Geotechnical Investigation

Proposed Residential Development

4386 Rideau Valley Drive
Ottawa, Ontario

Report PG5828-1 Revision 5 dated July 19, 2024

Figure 3 - Section A - Existing Conditions - Seismic Loading

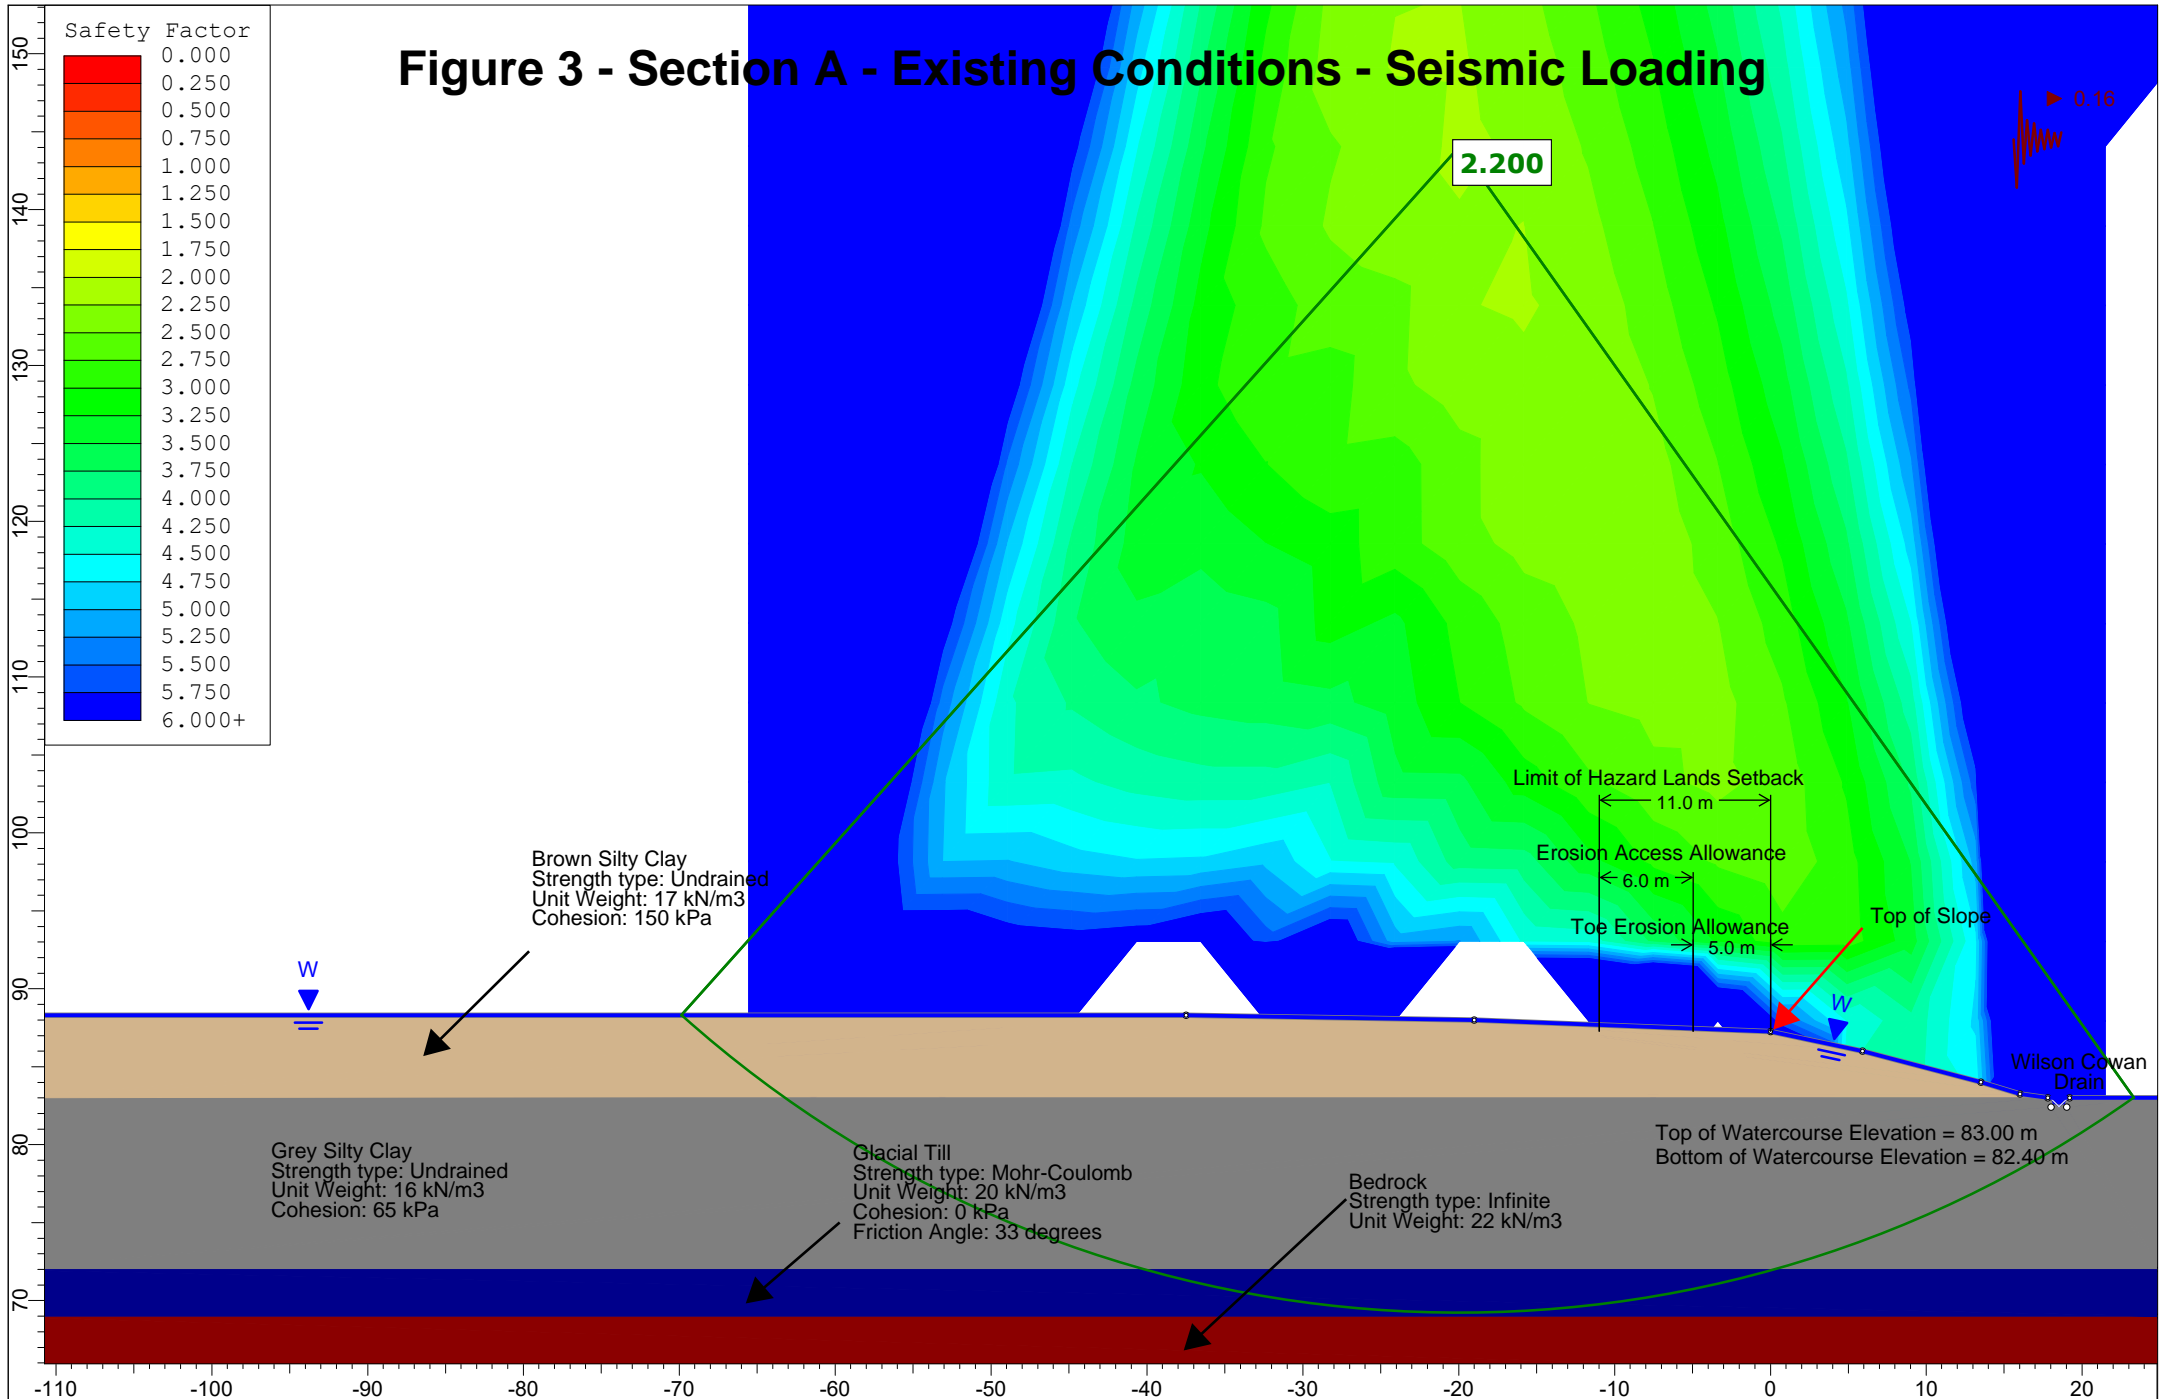
Comment 2.43

The soil annotations on Figure 3 appear to be floating.

(City02): Outstanding: *Referencing Figure 3, page 52 of 114, three soil types are indicated to be included in the slip circle. Also note that grey silty clay soils are a significantly weaker soil and not considered homogenous. The City will need to see a couple of non-circular failure surface calculations.*

Noted. The annotations for soil layers in Figure 3 have been modified in the above-mentioned revised report.

This comment has been acknowledged. Multiple non-circular failure surfaces have been added to Figure 3. Please refer to the above-mentioned revised report.

Figure 4 - Section B - Existing Conditions - Static Loading

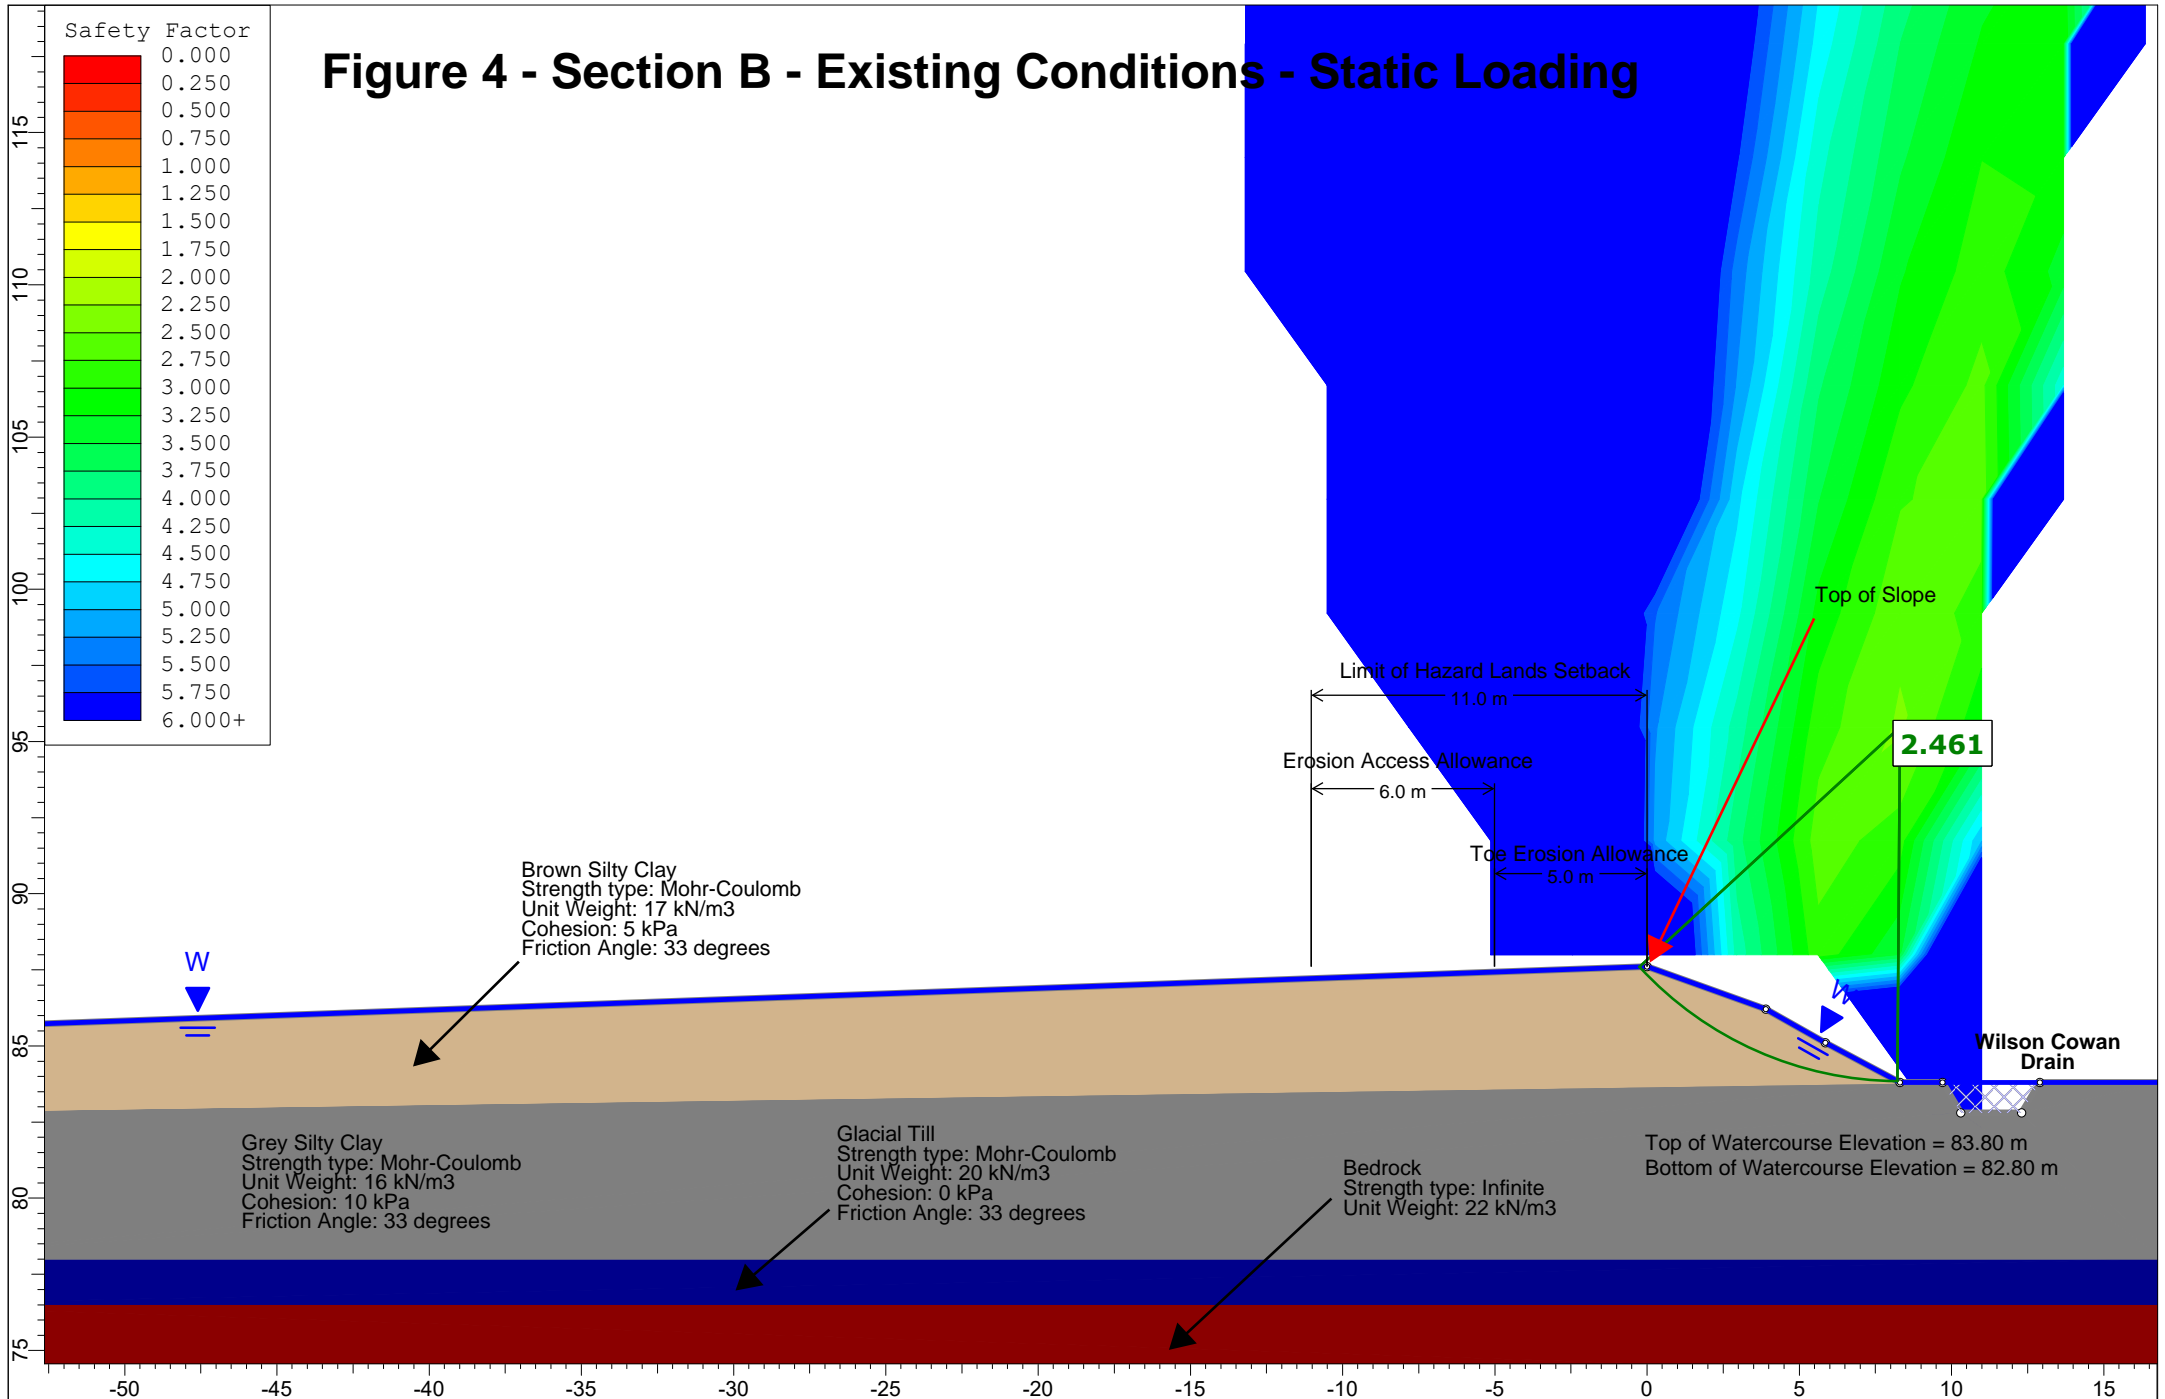
Please include bathymetric survey data used for Figure 4 (amongst others).

The bottom elevations of the watercourses at the studied cross sections has been determined using a high precision GPS, during our site visit to review the slope conditions. These elevations have been added to the slope cross sections included in the revised geotechnical report referenced above.

Figure 1. Criteria for evaluating liquefaction susceptibility of fine-grained soils (Bray et al. 2004).

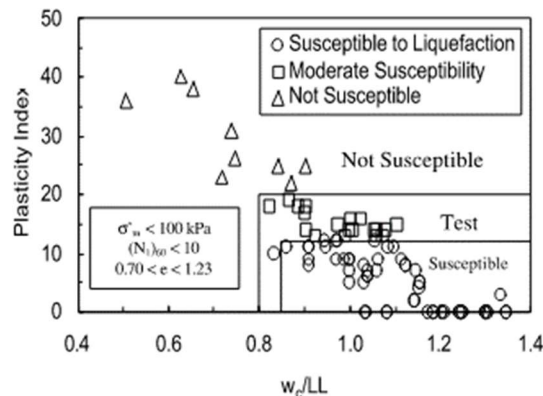
(City01): Comment 2.27 *The comments that the subject site are not susceptible to liquefaction requires an exhaustive discussion: whichever approach the consultant takes will require proof of similitude and full copies of papers provided to the City showing unequivocal support.*

(City02): Outstanding: *While the City understands the comparison implied here, we need to see testing or other data that confirms that this specific site meets these requirements.*

Paterson's Previous Response: The soils encountered at the subject site consist of silty clays, which are cohesive in nature. These soils were evaluated for liquefaction susceptibility in accordance with the criteria prepared by Bray et al. 2004 which determines that all soils with a plasticity index exceeding 20% are not liquifiable (Figure 1). In general, the plasticity index results completed on samples taken from the silty clay layer were found to be above 20. Therefore, the encountered soils are not susceptible to liquefaction. Reference should be made to subsection 5.4- Design for Earthquakes in the abovementioned revised geotechnical report, for further details on liquefaction susceptibility at the subject site.
